**RE: NPDES Reconnaissance Inspection and
Notice of Violation**

Mr. Todd Dugan
V.E. Beard Oil Co. Inc.
6990 Lima Street
Huntsville, OH 43324

NPDES COMPLIANCE INSPECTION REPORT

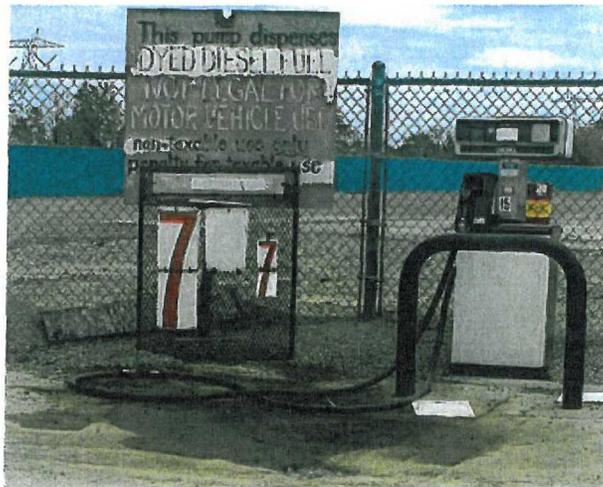
There were no issues associated with the storm drains serving the retail fuel islands but there was a significant amount of fuel on the ground around the tax-exempt diesel pump as shown the following picture:

Ms. Stevens recently informed me that a vehicle apparently ran over the hose, causing a rock to puncture it. She said the hose has since been replaced. I believe it is necessary to provide a better means of storing the long hose to minimize the chance of it being damaged.

This area of your facility's operations should otherwise be evaluated to ensure possible tank overfills are avoided or are quickly cleaned up using absorbent material. Please evaluate your SWP3 as it pertains to this unsheltered fueling station and let me know of any plans for making improvements.
